HYUNDAI Technical Service Bulletin	GROUP AUTOMATIC TRANSMISSION	NUMBER 23-AT-006H-2
	DATE NOVEMBER 2023	MODEL PALISADE (LX2) SANTA FE (TMA) SANTA FE HYBRID (TM/TMa HEV) SONATA (DN8A) SONATA HYBRID (DN8 HEV) TUCSON (NX4/NX4A) TUCSON HYBRID (NX4 HEV)
SUBJECT: AUTOMATIC TRANSAXLE PUSH-BUTTON SHIFTER DIAGNOSIS

This TSB supersedes TSB 23-AT-006H-1 to add additional information regarding harness damage repair for Tucson (NX4A), Step 6.

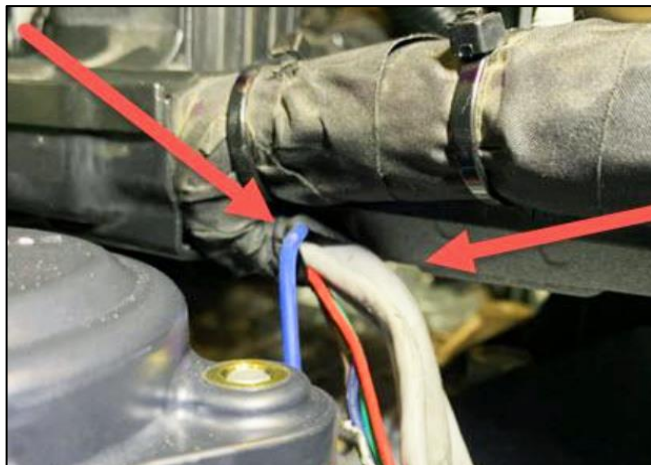
Santa Fe (TMa) 2.5L – VINs begin with 5NM:
Carefully unwrap the harness protector in the area shown below. Check the insulation on the wires to see if the insulation has been damaged by contact with the battery tray. If so, repair or replace the control harness.

Tucson (NX4/NX4A) 2.5L–VINs KM8 or 5NM:
Carefully unwrap the harness protector in the areas shown below:

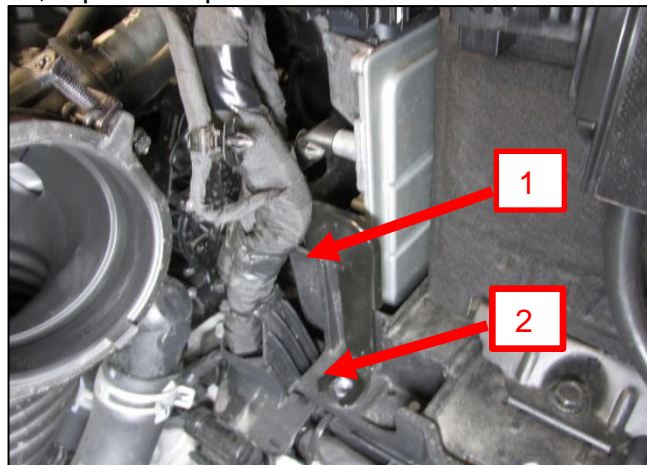
- 1. NX4 (KM8):** Check if the insulation has been damaged by contact with the metal bracket.
- 2. NX4A (5NM):** Check for broken wires in the area of the 90 degree bend in the harness. If so, repair or replace the control harness.

If replacing the control harness, make sure the replacement harness does not contact the battery tray or other components. Otherwise, the harness may become damaged again.
